INNER WEST COUNCIL

DEVELOPMENT ASSESSMENT REPORT

Application No.	10.2014.258.4
Address	88 Liverpool Road, Summer Hill
Proposal	Section 4.55(1A) modification to change the ground floor commercial tenancy into a 'SOHO' studio unit, and change approved winter garden screening and external materials.
Date of Lodgement	25 February 2019
Applicant	Nino Urban Planning & Development
Owner	MMNG Holdings Pty Ltd
Number of Submissions	Nil.
Value of works	\$1,480,500
Reason for determination at Planning Panel	Development to which SEPP 65 applies
Main Issues	Inadequate internal amenity, privacy and security for proposed 'SOHO' studio unit.
Recommendation	Approve in part subject to conditions
Attachment A	Recommended conditions of consent
Attachment B	Plans of proposed development

Figure 1: Proposed 'SOHO' unit location in relation to communal accessible ramp.

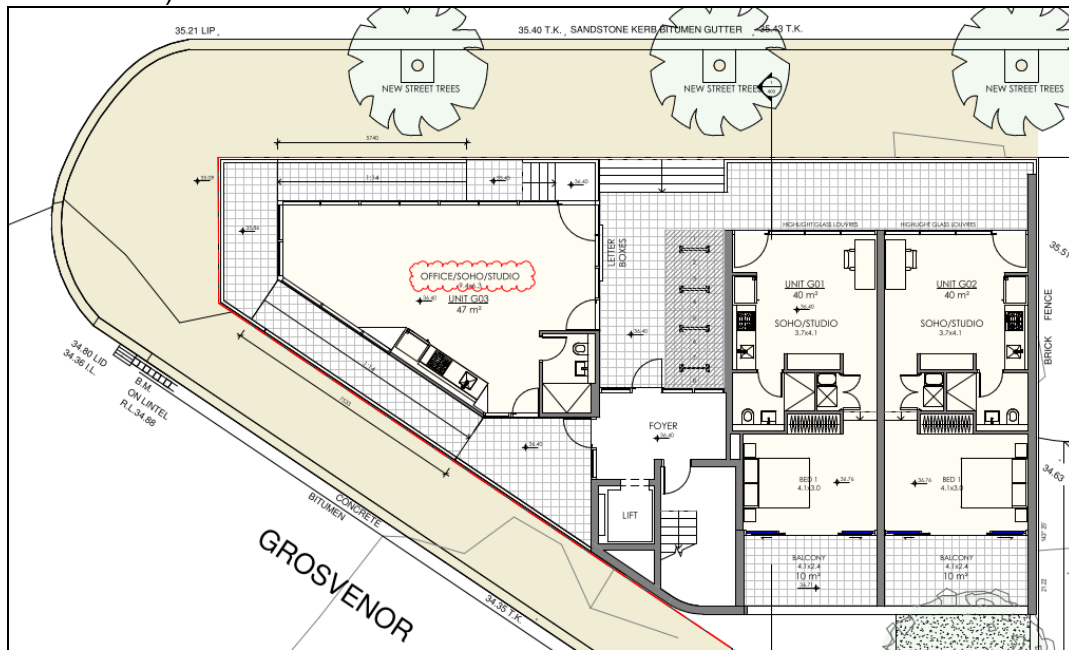
The 'SOHO' unit contains floor to ceiling glazing on its northern and western south-western edges, all of which are directly adjacent to the communal accessible ramp (see Figures 1 and 2 below) .

The proposed floor to ceiling glazing, in conjunction with the nil setback to the communal ramp and close proximity to Liverpool Road privacy treatment provide no internal privacy and would force future residents to choose between privacy and internal amenity (light and air) which is not supported.

Figure 4: Proposed screening to winter gardens.

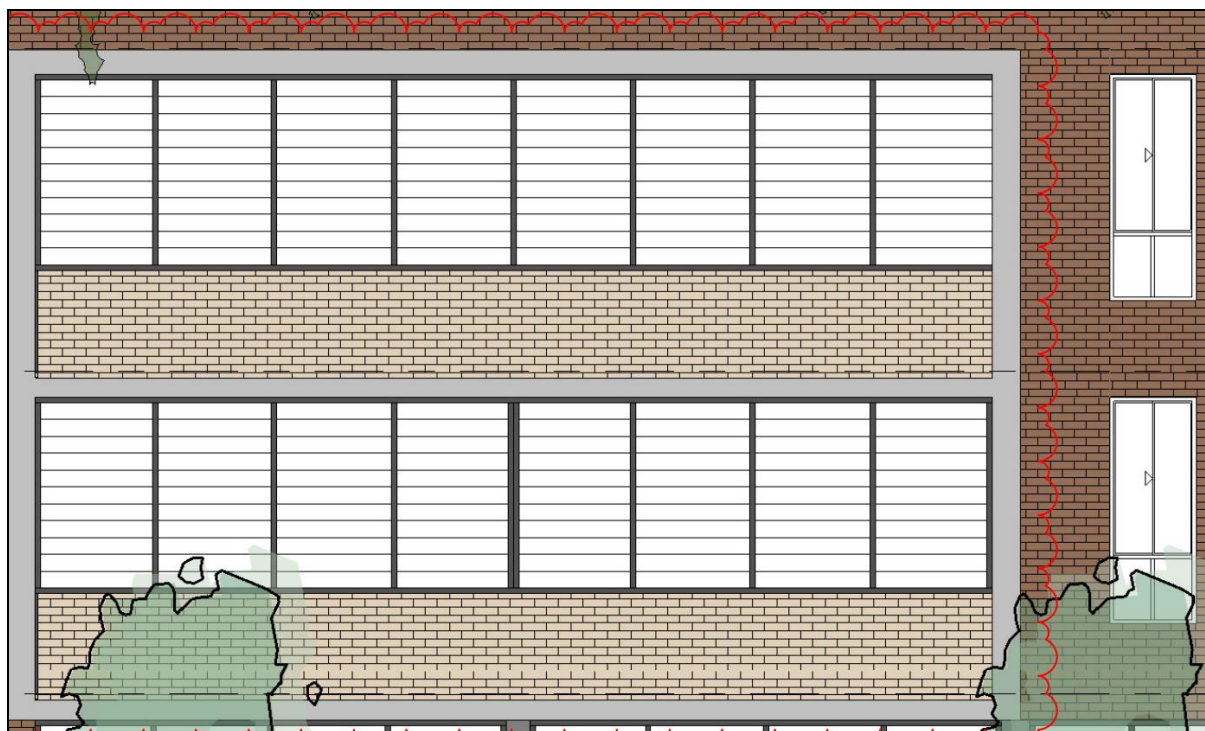
The revised drawings do not clearly show this gap and rather it appears to indicate that the balustrades directly adjoin the shutter frame railings (see Figure 4 below). To ensure this gap is maintained and the proposal does not increase the approved FSR, a condition of consent is recommend requiring the architectural elevations must be revised to clearly showing a gap of at least 150mm between all ‘winter garden’ balustrades and the glass louver frames to the satisfaction of Council similar to (Dwg Nos. 300 and 301 both Revision C and both dated 17 July 2018). A break between the glazing and the masonry is required not only for ‘technical compliance’ but also to reduce the sheer visual bulk of the

building which will have a more commercial presentation if its face is all read in one plane, rather than broken into articulated sections, more typical of a residential building.

The proposed deletion of Condition 1B is supported subject to it being replaced with a more appropriately worded condition.

The architectural elevations must be revised to clearly showing a gap of at least 150mm between all 'winter garden' balustrades and the glass louver frames to ensure the 'winter gardens' cannot be fully enclosed to the satisfaction of Council.

BASEMENT FLOOR

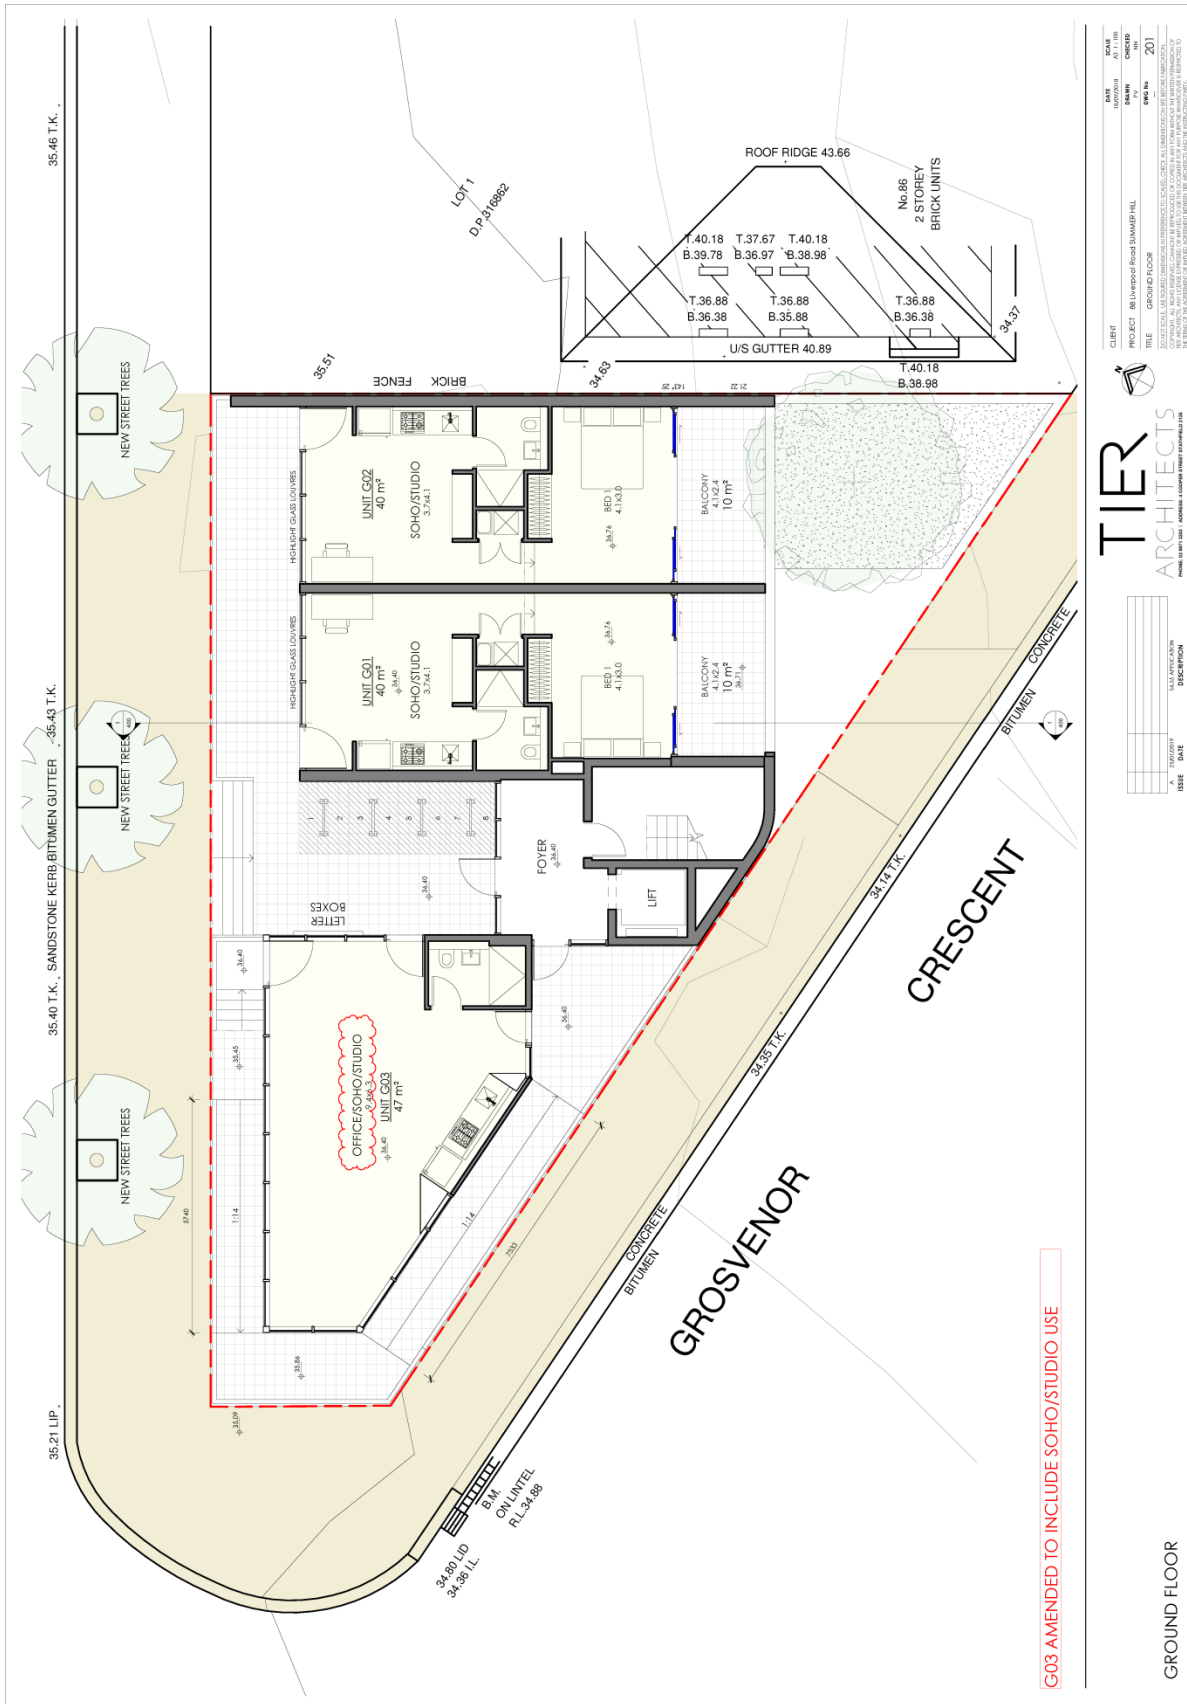
G03 AMENDED TO INCLUDE SOHO/STUDIO USE

GROUND FLOOR

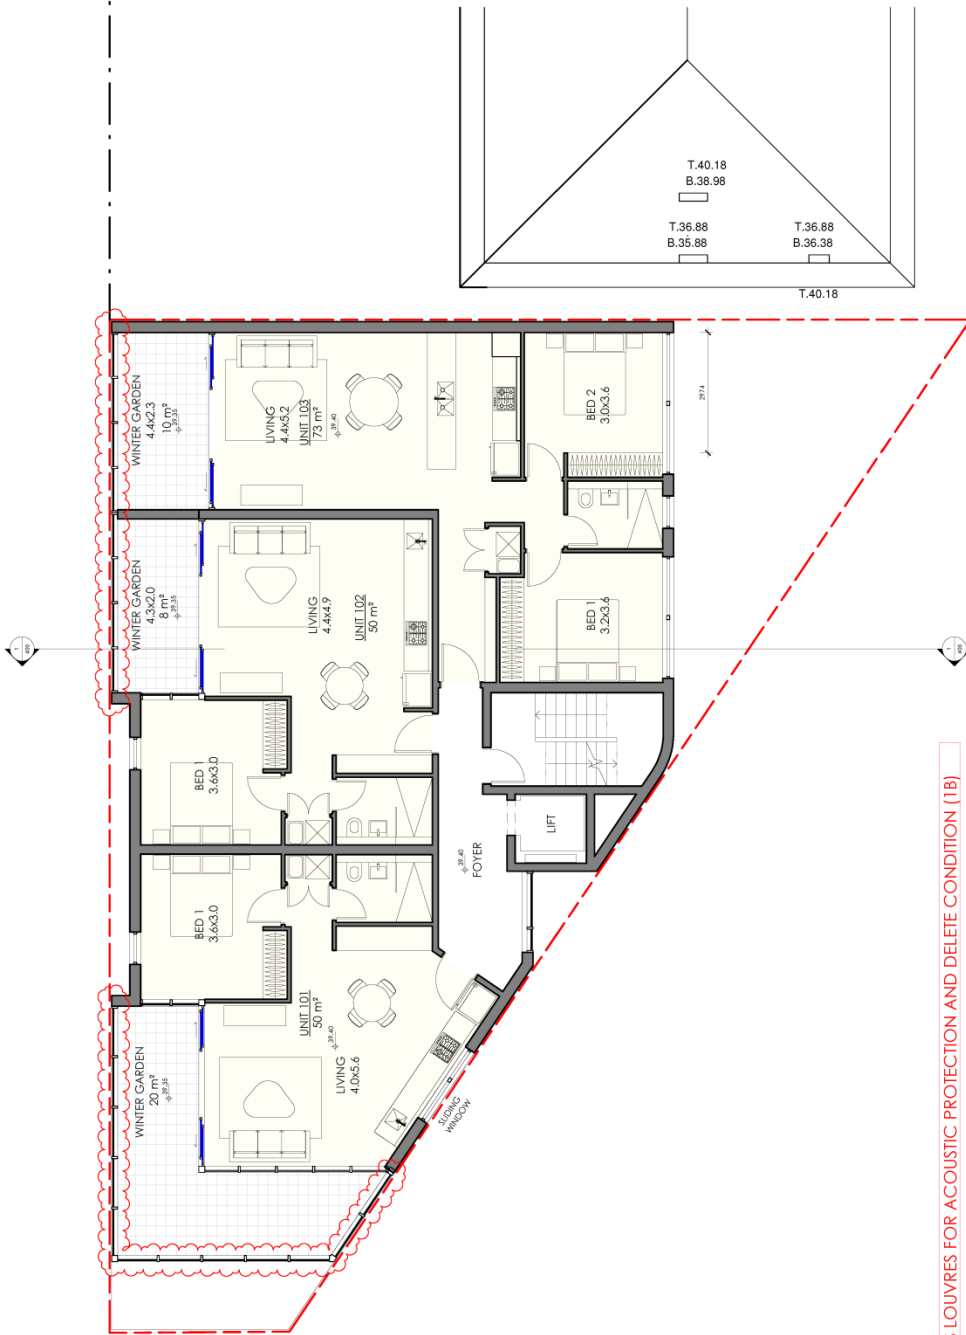
RE-INSTATE DA-APPROVED GLASS LOUVRES FOR ACOUSTIC PROTECTION AND DELETE CONDITION (1B)

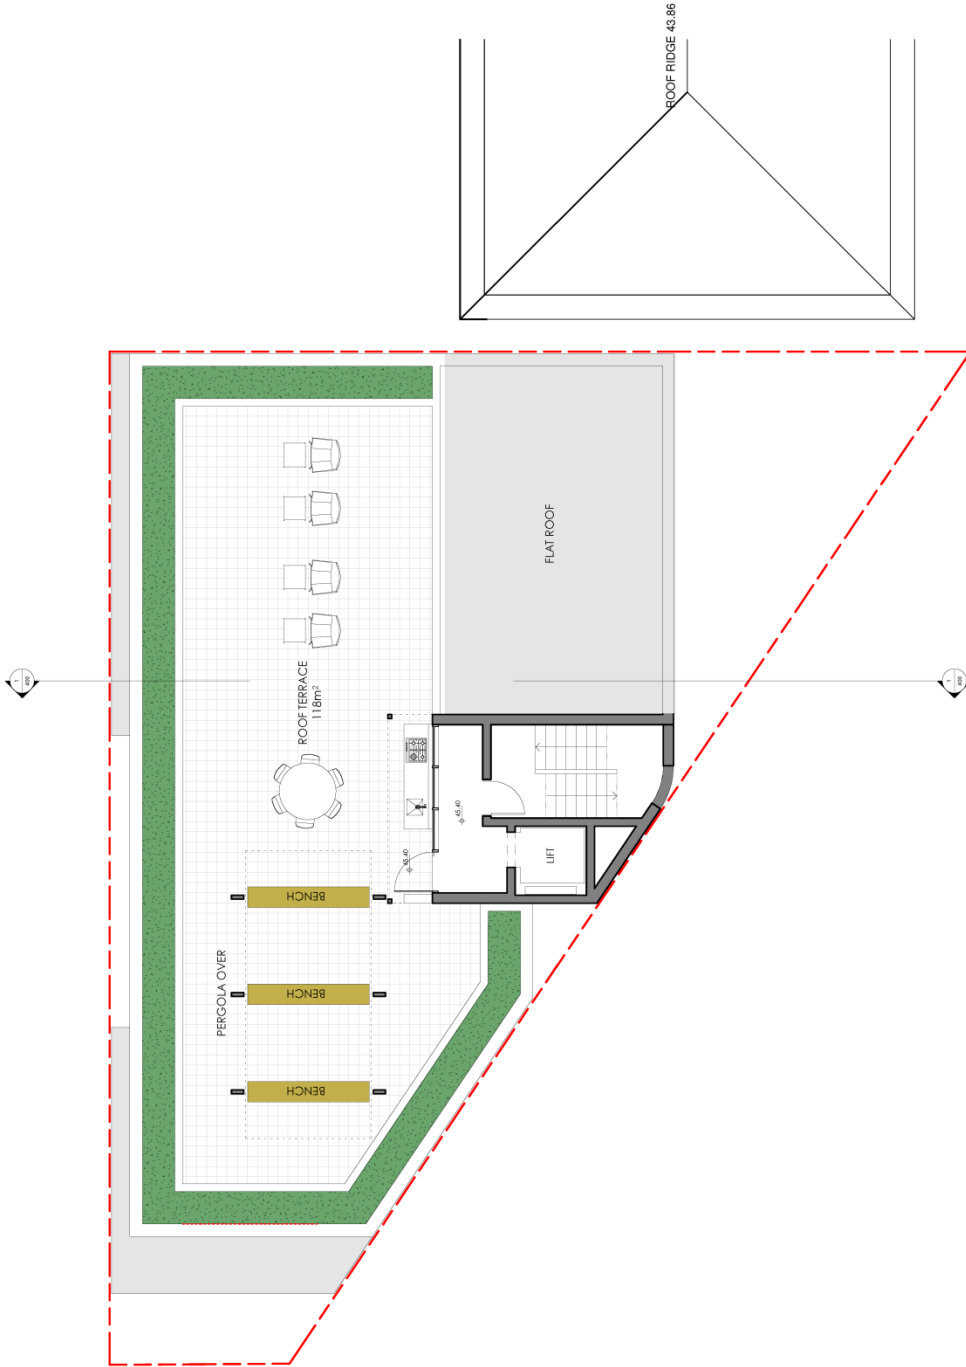
RE-INSTATE DA-APPROVED GLASS LOUVRES FOR ACOUSTIC PROTECTION AND DELETE CONDITION (1B)
 RE-INSTATE DA-APPROVED FACE BRICK AND DELETION OF CONDITIONS (1A) AND B(1)

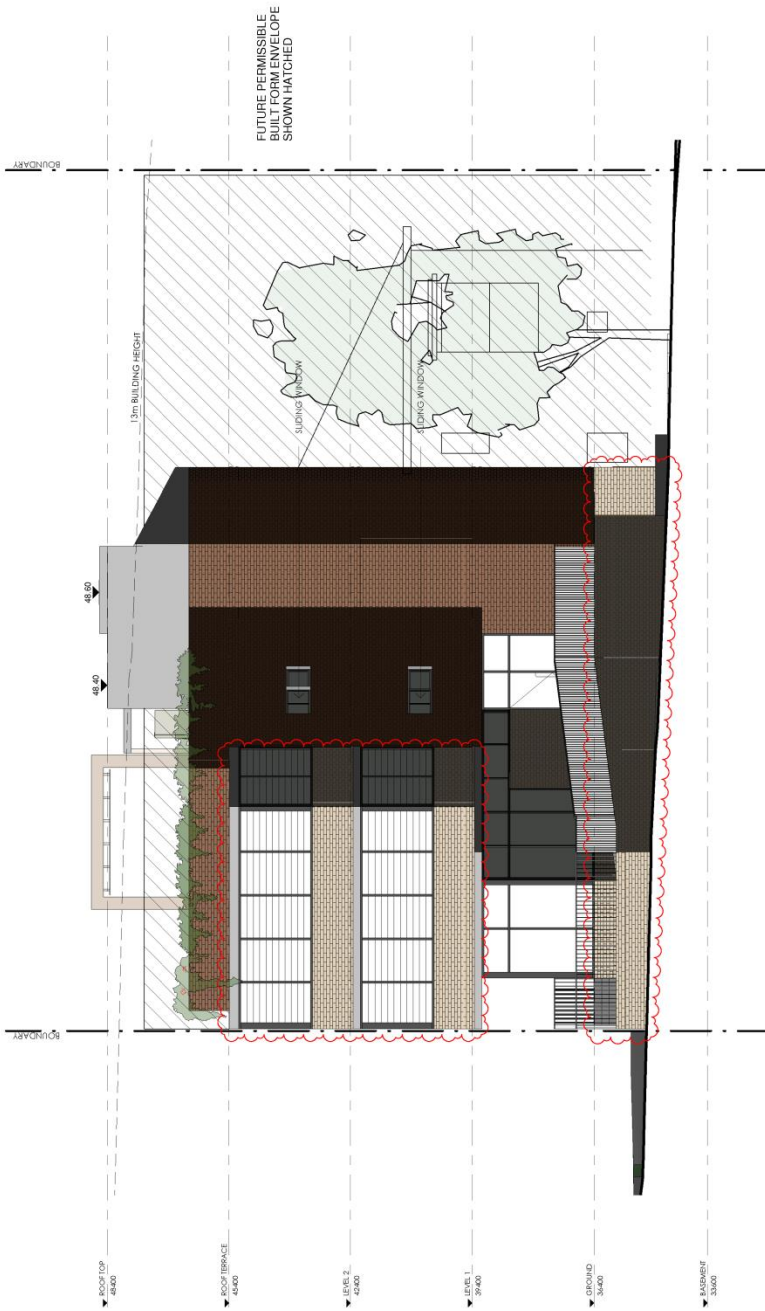
- RE-INSTATE DA-APPROVED GLASS LOUVRES FOR ACOUSTIC PROTECTION AND DELETE CONDITION (1B)
 - RE-INSTATE DA-APPROVED FACE BRICK AND DELETION OF CONDITIONS (1A) AND B(1)

WEST ELEVATION

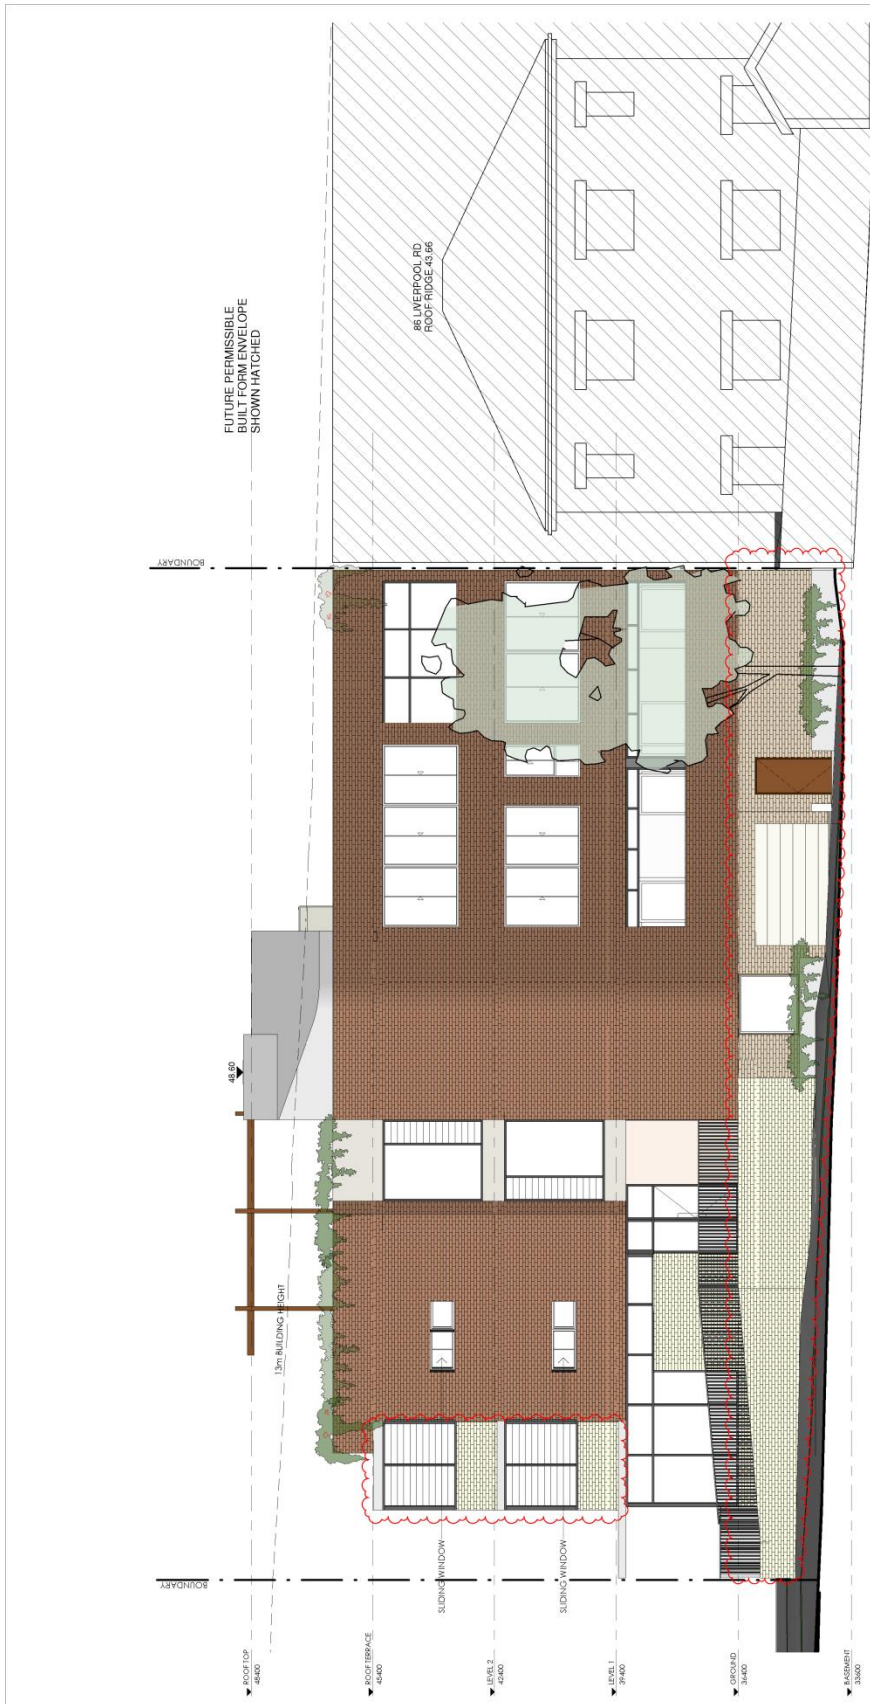
- RE-INSTATE DA-APPROVED GLASS LOUVRES FOR ACOUSTIC PROTECTION AND DELETE CONDITION (1B)
 - RE-INSTATE DA-APPROVED FACE BRICK AND DELETION OF CONDITIONS (1A) AND B(1)

EAST ELEVATION

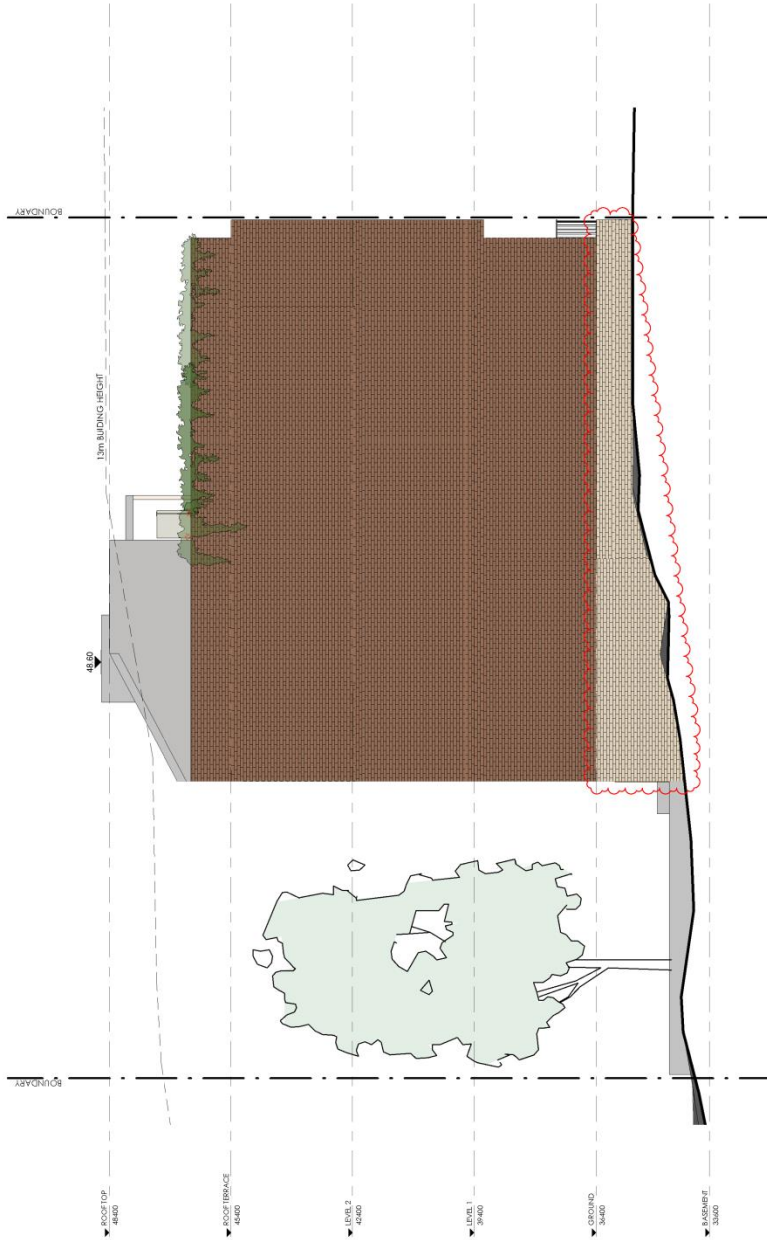
- RE-INSTATE DA-APPROVED GLASS LOUVRES FOR ACOUSTIC PROTECTION AND DELETE CONDITION (1B)
 - RE-INSTATE DA-APPROVED FACE BRICK AND DELETION OF CONDITIONS (1A) AND B(1)
